SERVICE No. 1123B BULLETIN

Date: April 20, 2006 (M)

SB 1123A Service Bulletin superseded SB 413 and SB 1123 in their entirety. SB 1123B adds instructions for PA-34-200 aircraft, S/N 34-7250001 thru 34-7350135 without "Upstop" kit 760-699 installed and revises effectivities for the PA-34-220T Seneca V aircraft.

**SUBJECT: PA-34 SERIES AIRCRAFT NOSE GEAR
 INSPECTION AND PRODUCT IMPROVEMENTS**

Figure 1
 Trunnion Inspection
 (See Table 1, Item 3)

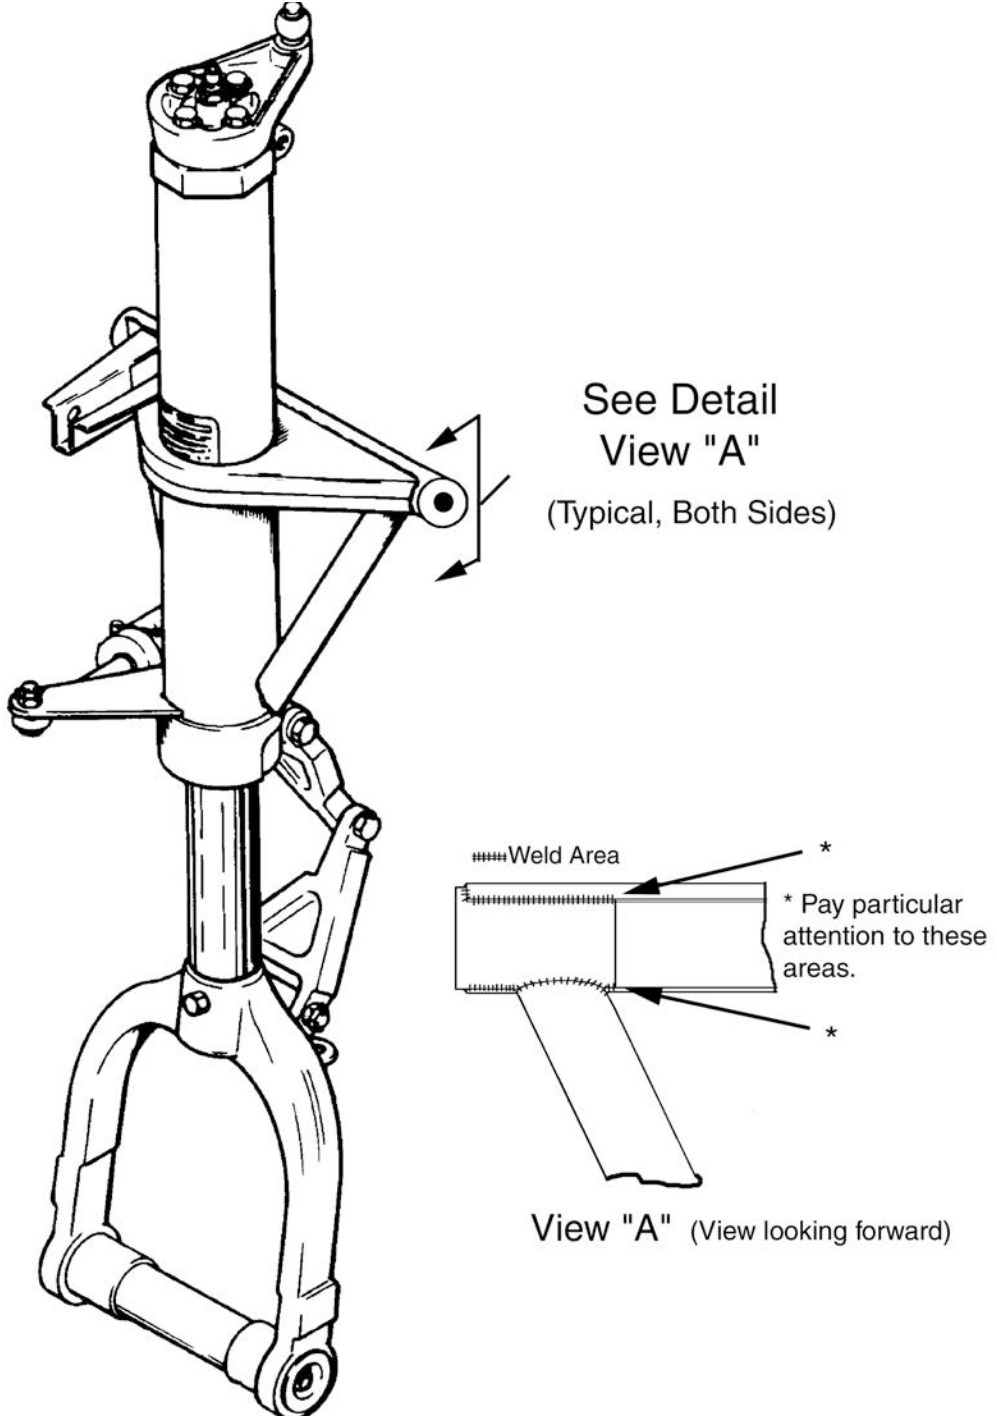
3. Visually inspect (2000 hrs. initial) the nose gear trunnion (P/N 95723-00, -05, -06) for cracks in the area of attachment to the nose gear mount assembly (See Figure 1) using supplemental lighting and a 10X magnifier				0

Figure 1A
Actuator Mounting Bracket Rivets

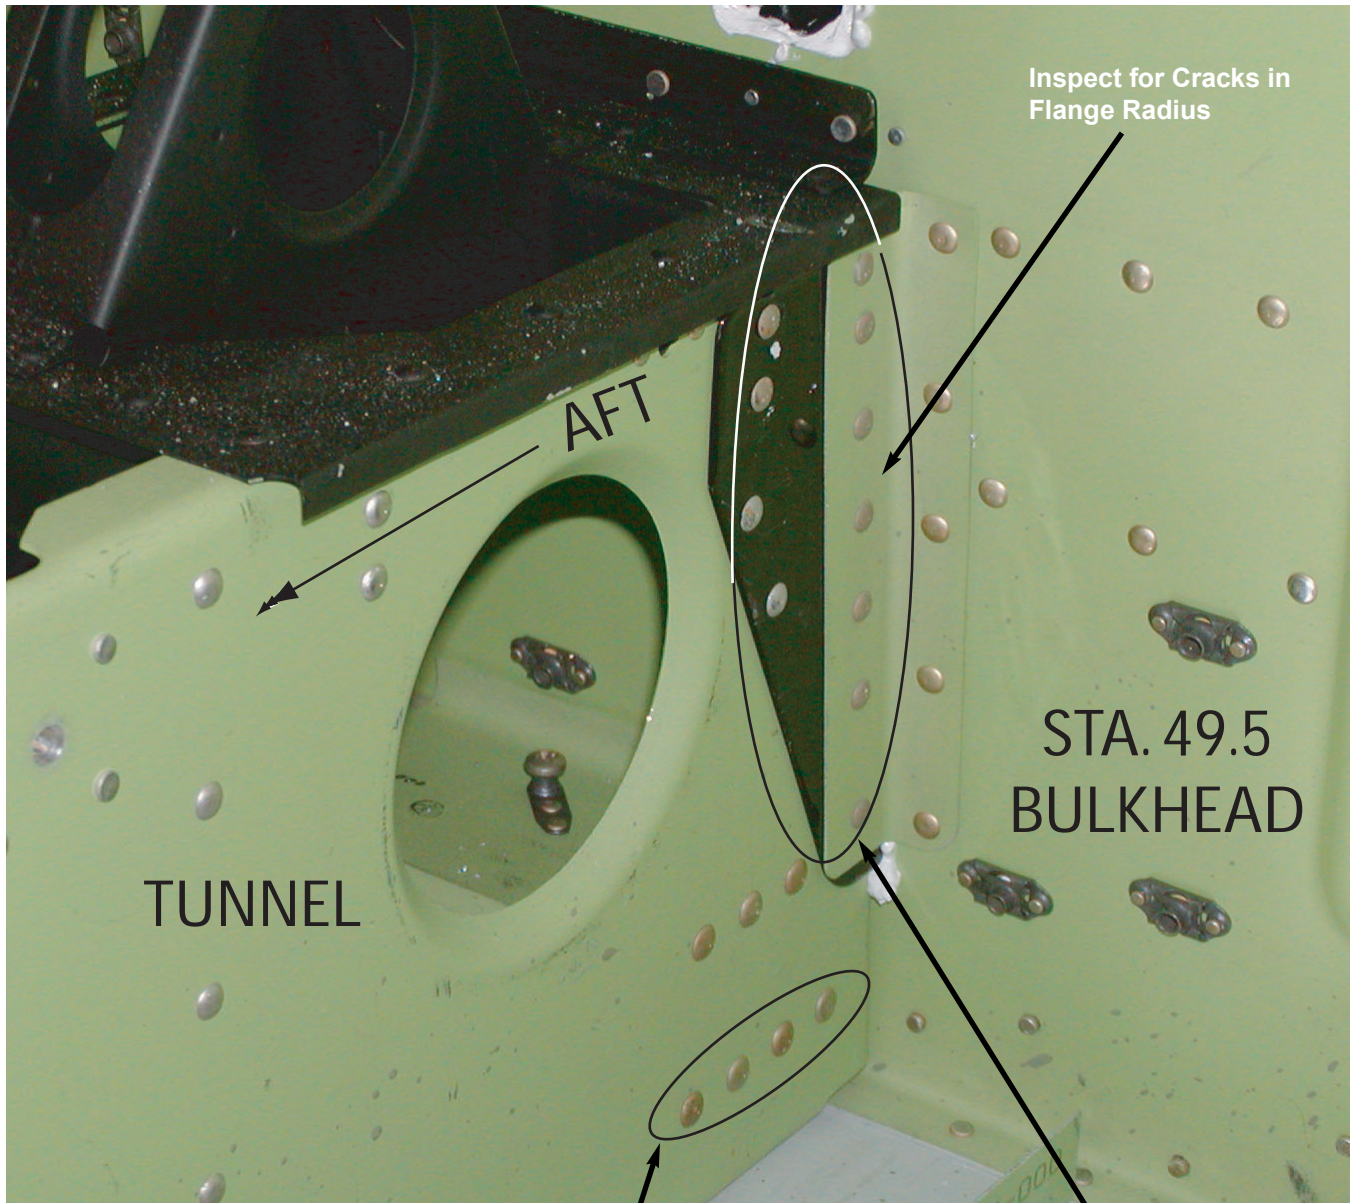
9. Inspect the actuator mounting bracket for cracks, elongation of the .250 dia. holes where the retraction link attaches, and for loose mounting rivets. (Reference Figure 1A for rivet inspection details) See paragraph 2. c. for aluminum -vs- steel mounting bracket inspections. See section 3 of this service bulletin for wear limits. See applicable S/N below. a. 34-7250001 through 34-7570050 b. 34-7570051 and Up For aircraft in category 9.a. that have had the steel mount bracket installed (95724-004 thru -007, as applicable), inspection requirements shall be per category 9.b.	0	0 0	0 0	0 0

<p>14. Inspect the Tunnel Bracket 95554-000 installation for loose attachment rivets to the tunnel and nose gear mount fitting 95555-000 and visually inspect for cracks in the bracket attachment flange adjacent to the fitting. This inspection can be accomplished through an access opening located in the bottom skin at B.L. 00.00, just aft of Sta. 49.5 bulkhead. Inspect for loose rivets by observing the area during the landing gear cycle test performed per Inspection No. 9. (Ref Figure 1A) and looking for any relative motion between riveted components.</p>		0	0	0
--	--	---	---	---

Inspect These (4 Rivets) for Attachment of Tunnel Bracket 95554-000.

Inspect These 11 Rivets

Inspect for loose mounting rivets that attach the actuator mounting bracket to tunnel aft of Sta. 49.5 bulkhead by placing aircraft on jacks, extend and retract landing gear and note any relative motion between the subject bracket and the tunnel. It will be necessary to pull carpet away from the side of tunnel to inspect noted rivets.

Figure 2
Service Wear Limit Locations

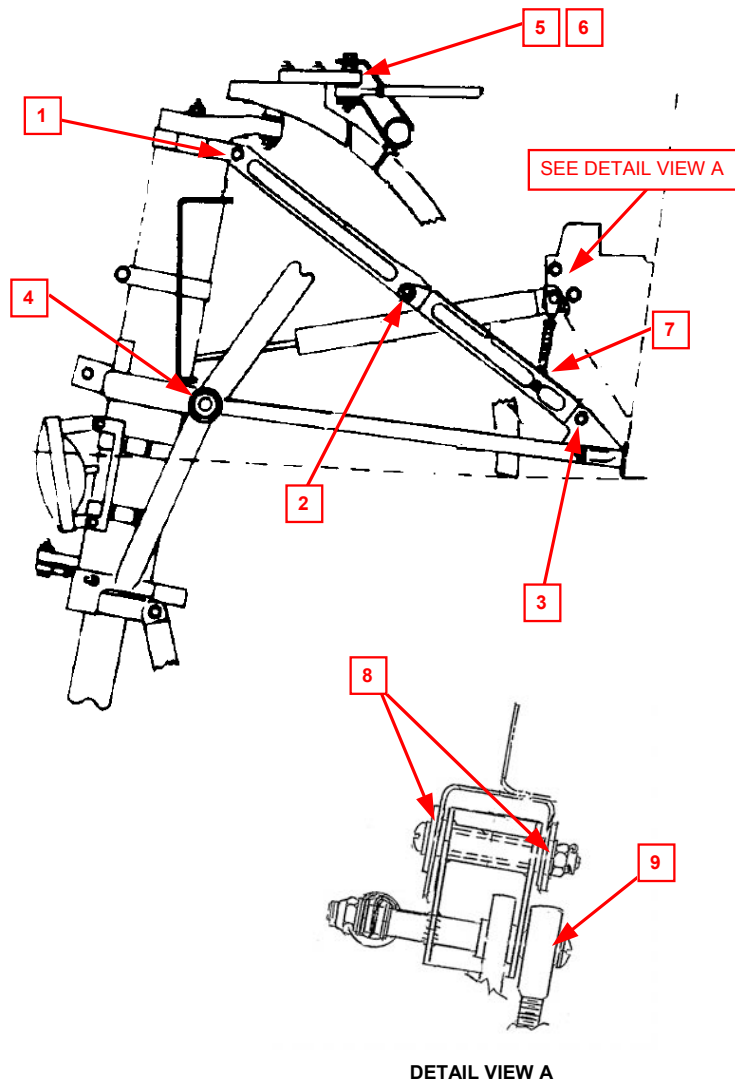
Table 3 is a "Wear Limits Chart" that can be used to determine the acceptable /or replacement condition for the listed parts that were inspected per Instructions Step 1. in this Service Bulletin. Visually inspect all bolts/pins for wear, damage, or corrosion. Replace as required.

Figure 3
Drag Link Over-Center Measurement
Nose Gear Installation

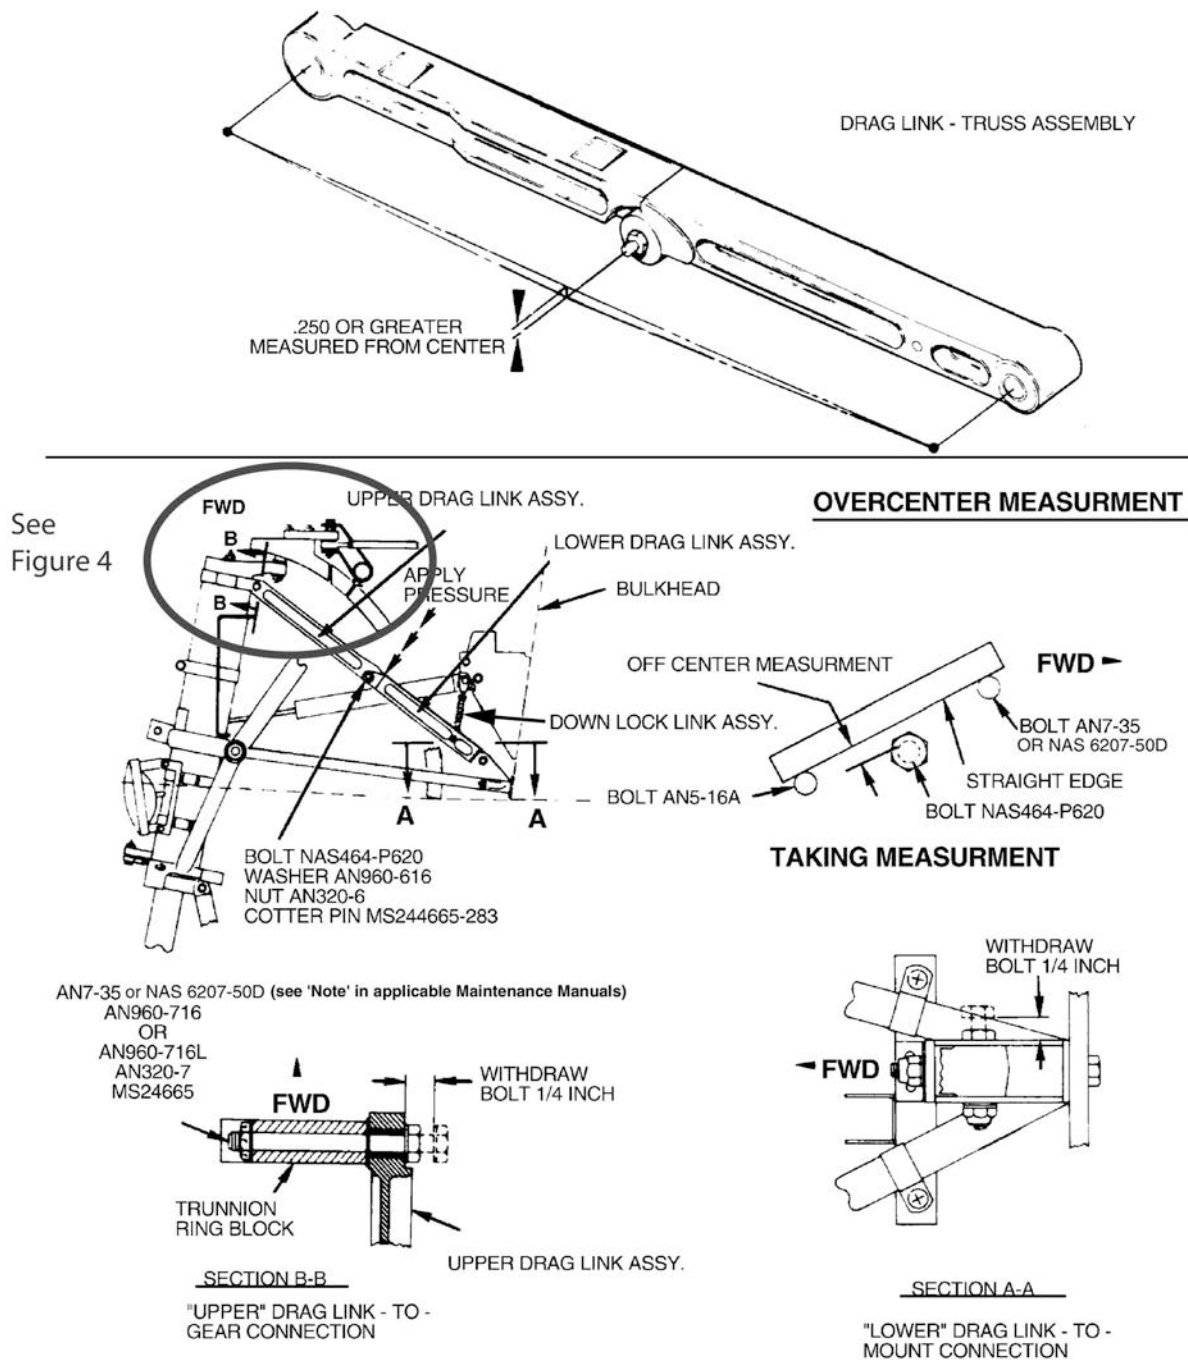
- a. For Senecas serial numbers 34-7250001 through 34-7450220: Rigging of the nose gear installation (Item 13, Table 1) shall be accomplished per this Service Bulletin. The 'over center' measurement for the Seneca, as for all Senecas, shall be 0.250 or greater as measured from the center (See Figure 3). The Service Manual will be revised to delete reference to Service Bulletin 413. All required measurements are in this service bulletin and will be incorporated into the Service Manual.

- b. For Senecas II through V: Rigging of the nose gear installation (Item 13, Table 1) shall be accomplished per the appropriate Service Manual with the following exception for the Seneca II. The 'over center' measurement for the Seneca II, as for all Senecas, shall be 0.250 or greater as measured from the center (See Figure 3). The 0.250 dimension supersedes the 0.300 dimension which was incorrectly stated in the Seneca II Maintenance Manual. Refer to the Maintenance Manual for the procedure to make the over center measurement. This Service Bulletin supersedes Service Bulletin No. 413, Nose gear Drag Link Dimension Check.

Figure 3A
Nose Gear Installation

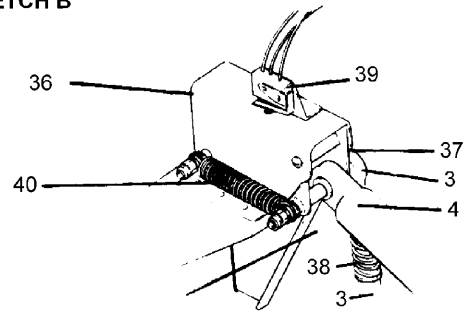
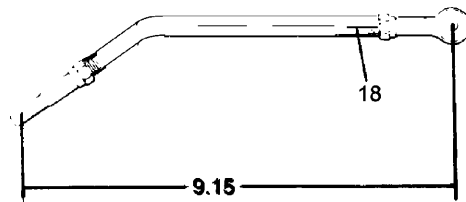
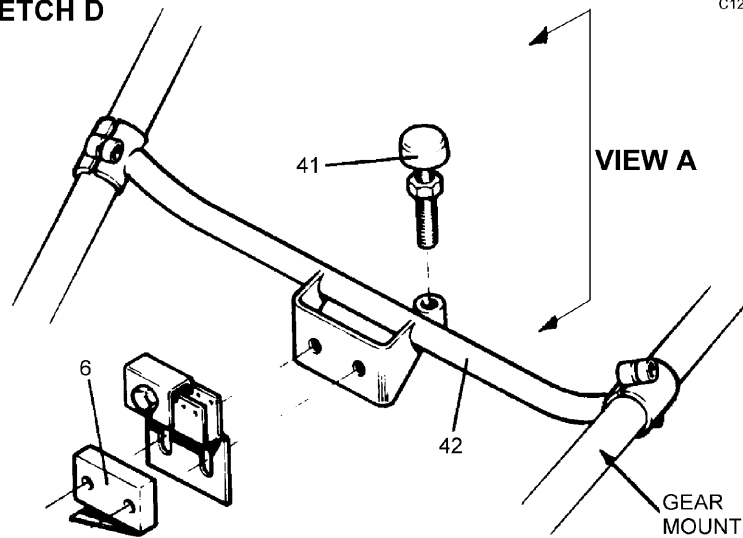
NOTE: Upstop NOT installed on PA-34-200 aircraft S/N 34-7250001 through 34-7350135 unless Kit 760-699 has been complied with.

- e. At the actuator housing attachment assembly (see Sketch B, Figure 3A), disconnect the retention spring from the retraction link fitting.
- f. Position the gear in its down locked position and check that the drag links have fully extended to their through center position with the stop surfaces in contact.

Figure 4
Steering Arm Channel Clearance

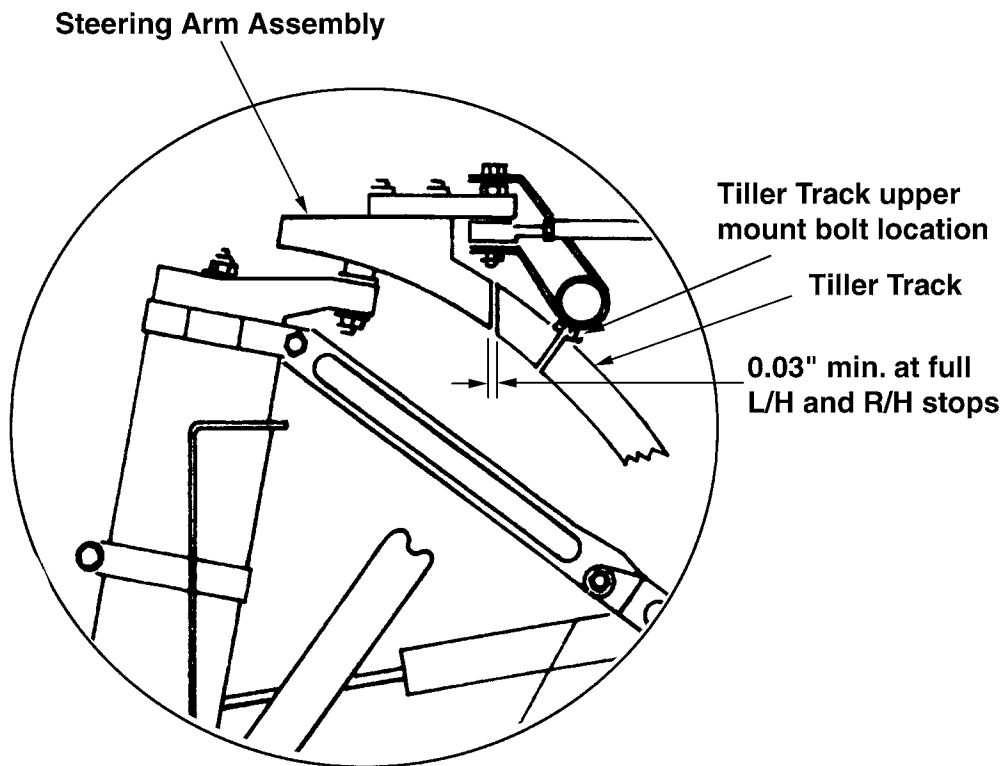
- a. Turn the nose gear full travel and make sure the clearance between the steering arm assembly and the tiller track is a minimum 0.03 of an inch at both the left and right stops. (see Figure 4). If insufficient clearance is obtained, loosen the upper mounting bolts for the tiller track and move the track upwards in the slotted holes where the track is attached to the gear mount assembly. Adjust to obtain a minimum clearance of 0.03 of an inch. Tighten the upper mounting bolts.
